**Review of the
Kibby Expansion Wind Project
Aesthetic Impact Assessment**

James F. Palmer

Scenic Quality Consultants
Burlington, Vermont

April 16, 2010

Figure 1. Kibby Expansion Visibility over Forested Cover

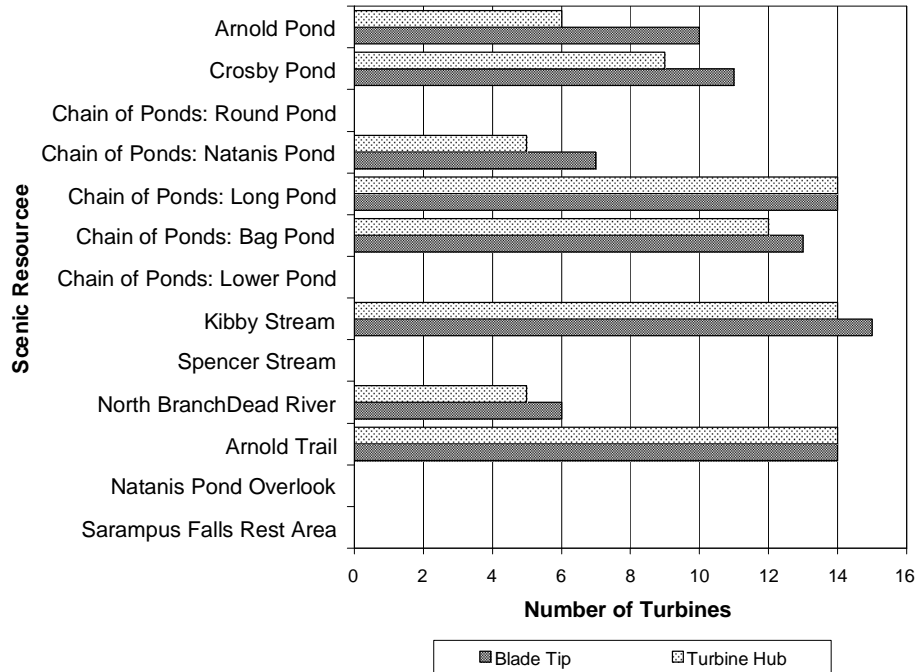
Table 2 summarizes the maximum number of Kibby Expansion blade tips and turbine hubs that may possibly be visible within 8 miles of the significant scenic resources under the three different visibility constraints. Figure 1 charts the maximum potential number of blade tips and turbine hubs potentially visible over forested cover for each of the significant scenic resources.

The most important finding revealed by these viewshed maps is that several significant scenic resources will not have visibility of the Kibby Expansion turbines: Round Pond, Lower Pond, Spenser Stream, Natanis Pond Overlook, and Sarampus Falls Rest Area. An inspection of the viewshed maps 1 and 2 shows that the overall area with potential views of the turbines is greatly decreased with the consideration of forest screening—from over 40 percent to about 8 percent. Similarly, a comparison of maps 2 and 3 shows that assuming harvested areas have the same screening affect as a full forested canopy greatly decreases the potential visibility once again—from about 8 percent to about two percent. Unfortunately different ways of considering visual screening have only modest affect on turbine visibility from Arnold Pond, Chain of Ponds, and Crosby Pond. However, they make a big difference in evaluating the potential impact to the Arnold Trail, Kibby Stream, and North Branch Dead River. Fieldwork is particularly necessary to establish the affect on visibility from these three significant scenic resources.

In this analysis there is relatively little difference between whether the viewed target is the tip of an upright blade, or the center of the turbine hub. In most areas with potential visibility a substantial portion of some turbines will be visible.

Figure 2. Kibby A, B & Expansion Visibility over Forested Cover

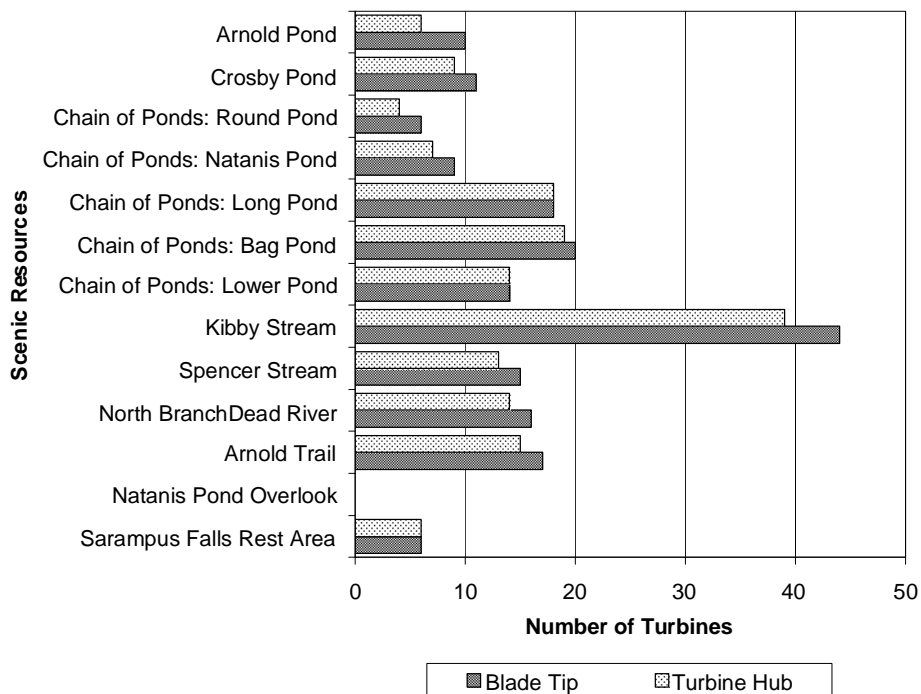
Table 3 summarizes the maximum number of Kibby A, B and Expansion blade tips and turbine hubs that may possibly be visible within 8 miles of the significant scenic resources under the three different visibility constraints. Figure 2 charts the maximum potential number of blade tips and turbine hubs potentially visible over forested cover for each of the significant scenic resources.

This analysis indicates that some areas in the APE that will not have views of the Kibby Expansion may have views of the Kibby A or B turbines: Round Pond, Lower Pond, Spencer Stream, and the Sarampus Falls Rest Area. However, Kibby Stream is the significant scenic resource that will potentially be seriously impacted by both the Kibby A and B Developments and the Kibby Expansion. Again, this result suggests that there is a need for fieldwork, and possibly visual simulations, to verify the extent and magnitude of these potential scenic impacts. For instance, it may be that shoreline vegetation may screen all or most views from Kibby Stream. It is unfortunate that there is no information about “the expectations of the typical viewer” and “extent, nature and duration of potentially affected public uses” of Kibby Stream.¹⁸

ArcScene Visualization from Viewpoint 2

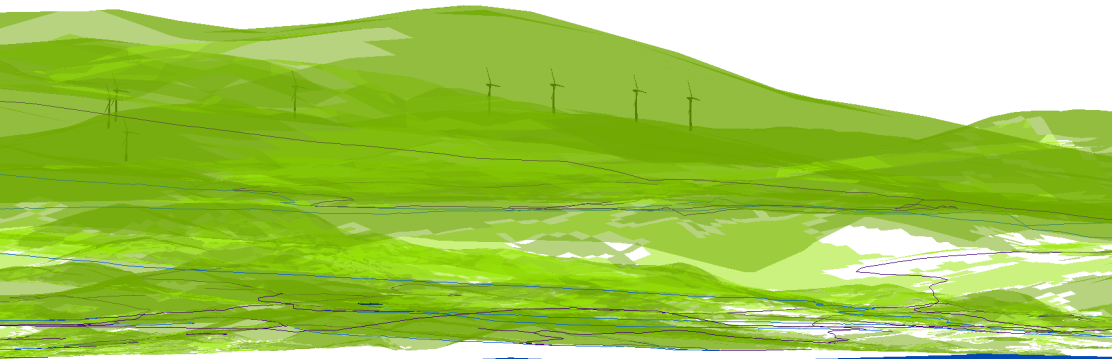
Overall the ArcScene visualizations are similar to the VIA simulations. The scale and contrast match is very good for Viewpoint 1 in the southeastern portion of Natanis Pond. No turbines are visible from Viewpoint 2 at the Narrows between Natanis and Long Ponds. Walking on the frozen lake approximately 480 feet to the south to Viewpoint 3, two turbines become visible around the shoulder of the hill. Again the scale and contrast appear to be reasonable. Continuing south another 315 feet, four turbines are clearly visible at Viewpoint 4. The simulation and visualization show a similar scale for the turbines. However, the turbines in the simulation have unacceptably low contrast, making it difficult to distinguish them. Viewpoint 5 is on Long Pond looking up the Clearwater Brook valley. The same turbines are shown in both the simulation and visualization. However, the turbines in the simulation appear a bit shorter, though this may be due to the visualization turbines being darker, or the slight deviations in registering the turbines to the terrain. More important is that the turbine's contrast seems low. Viewpoint 6 on Bag Pond looks up the Gold Brook valley. Again, the turbines in the simulation appear a bit smaller. In addition, turbines T-4 through T-7 are more exposed in the simulation than in the visualization, while turbine T-10 is more exposed in the visualization, and the blade tips of turbines T-12 and T-13 are not visible in the simulation at all. Among other reasons, this might happen because the photograph and 3D CAD model are not completely registered in the simulation. Perhaps T-12 and T-13 are behind the pine tree that breaks the ridgeline. The turbines in this simulation also suffer from unacceptably low contrast.
